Town of Montgomery Police Station

ADDENDUM #2: April 17, 2025

General Summary:

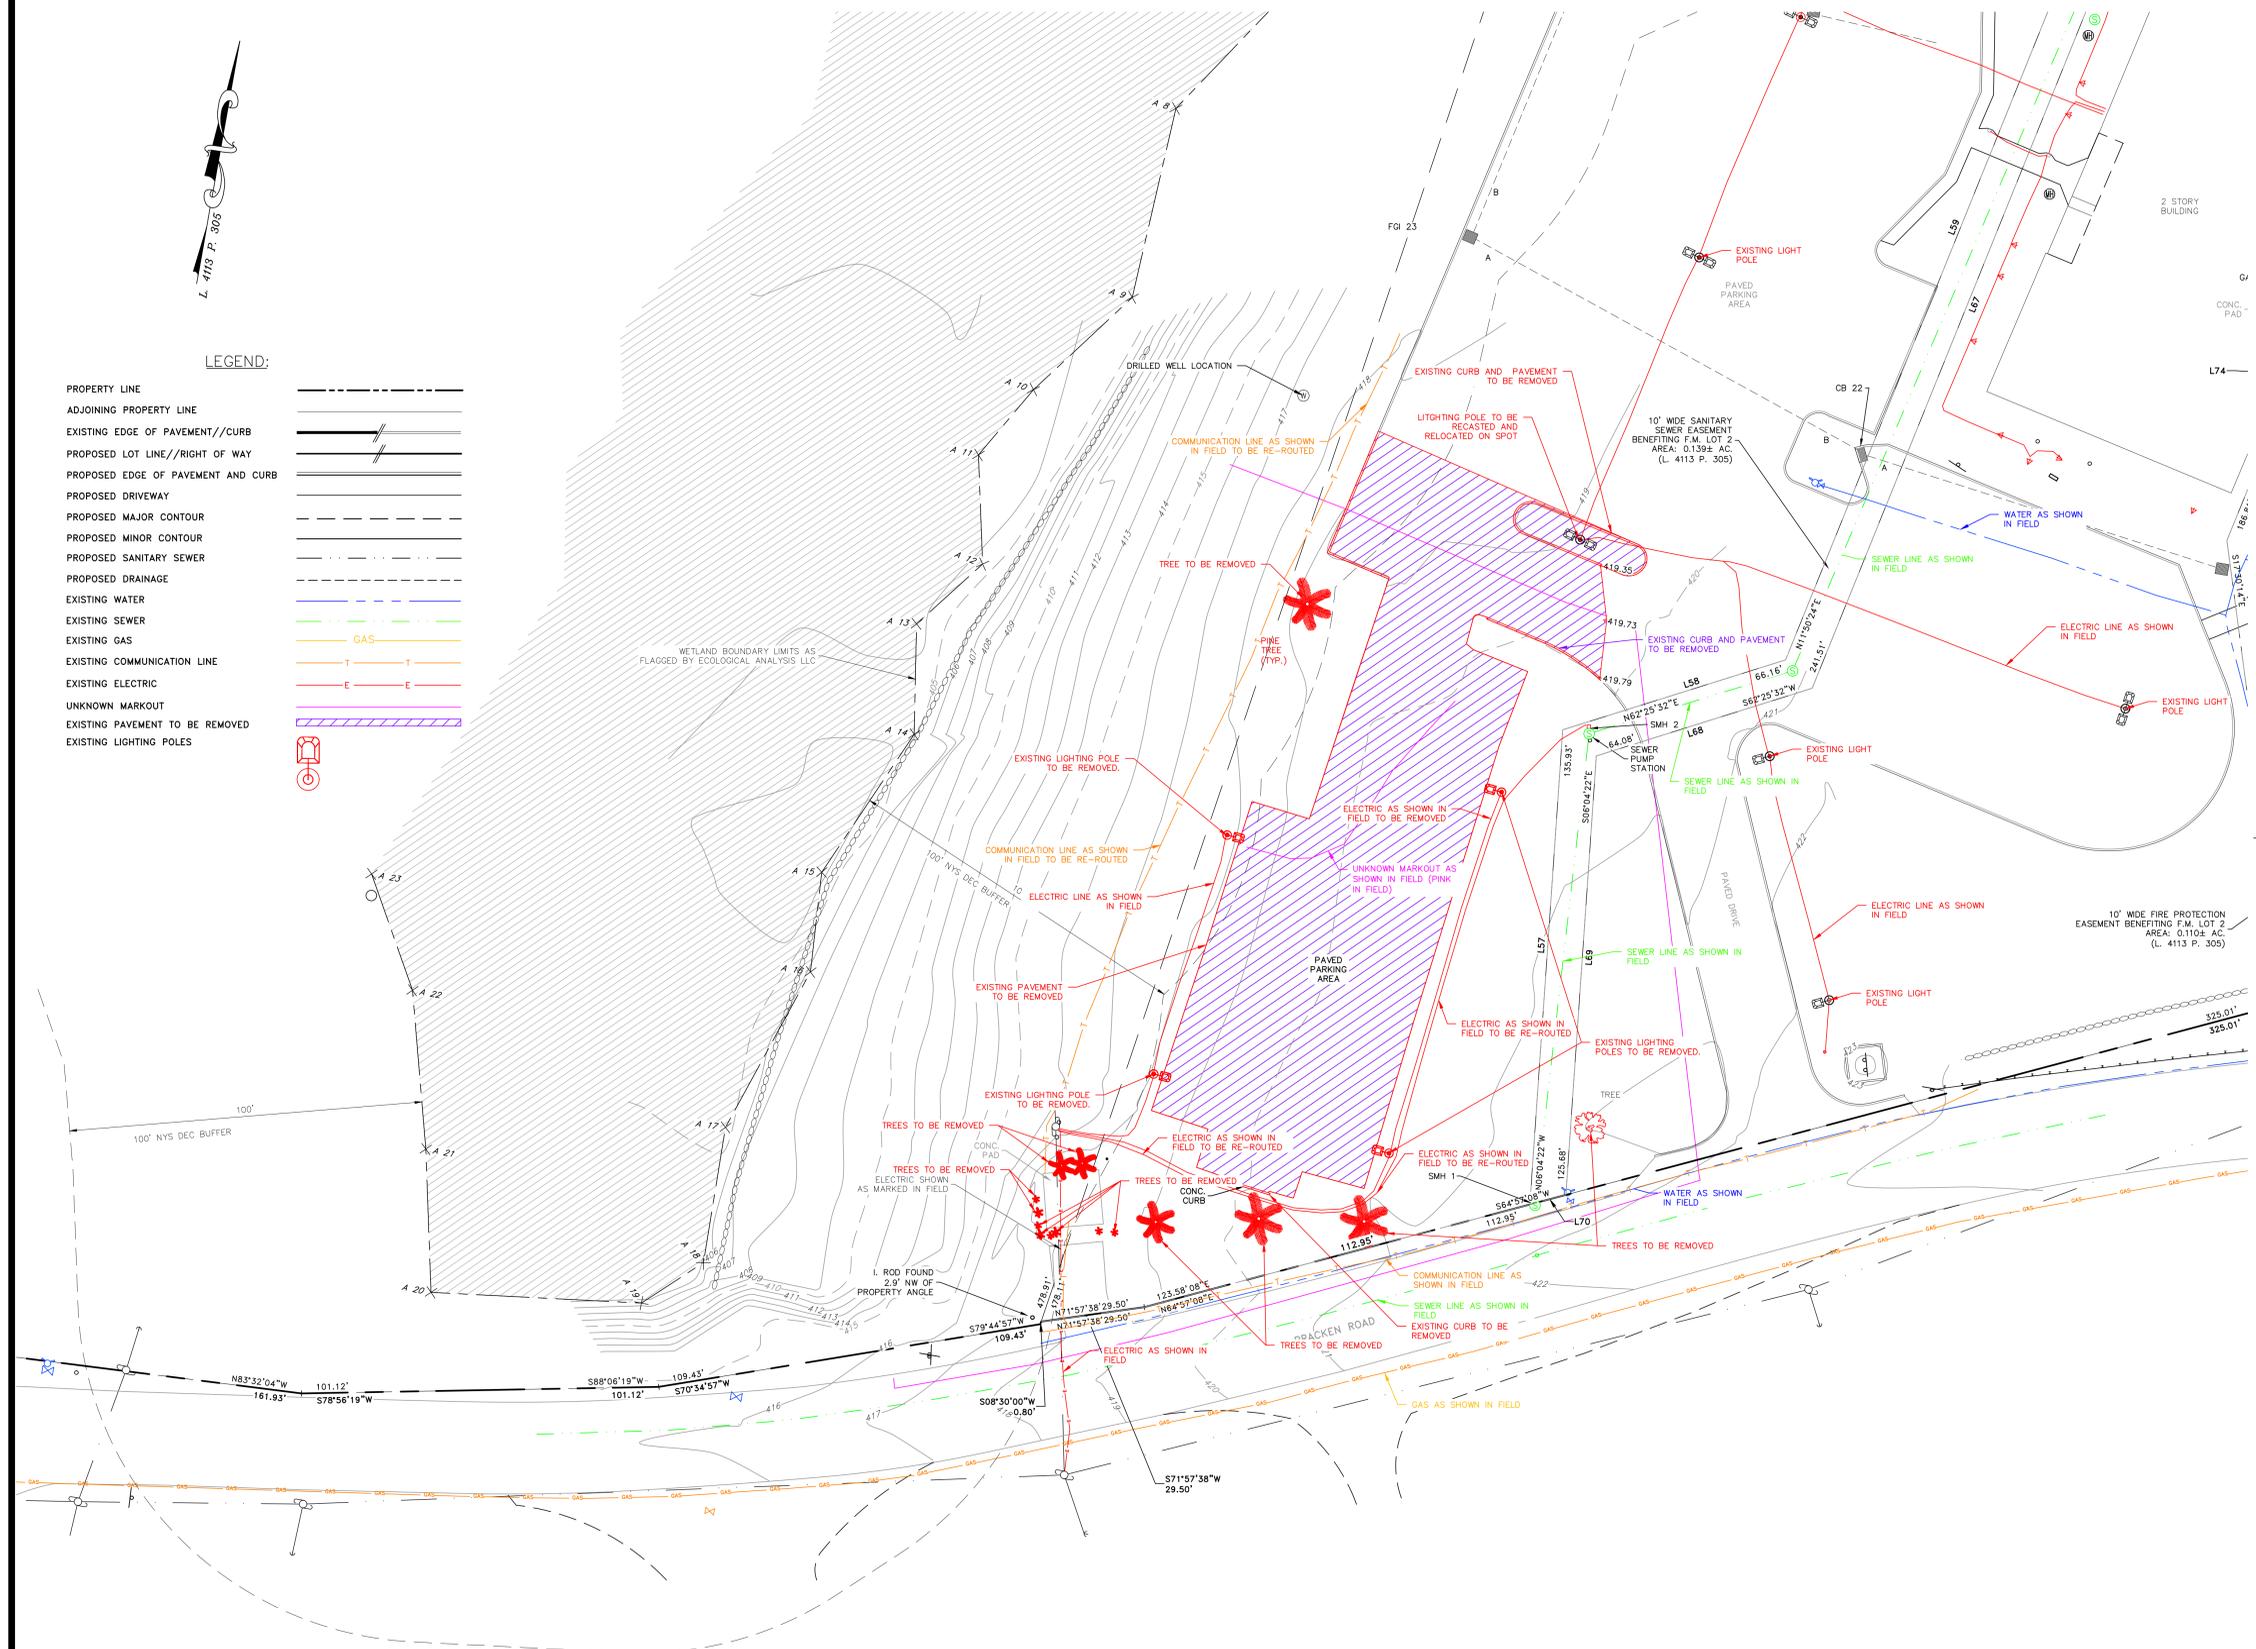
11. **As a notification**, civil drawings 1 of 6 - Existing Conditions and Demolition Plan, 2 of 6 – Site Plan, 3 of 6 - Grading, Utility, and Lighting Plan, and 4 of 6 – Overall Site Plan have been updated to include additional tree removal, fencing, and light/pole specifications and base details.

20. Please confirm the pole lights.
- RESPONSE:** There are (2) new pole lights shown on the civil drawings. The light/pole specifications and base details have been added to the civil drawings.
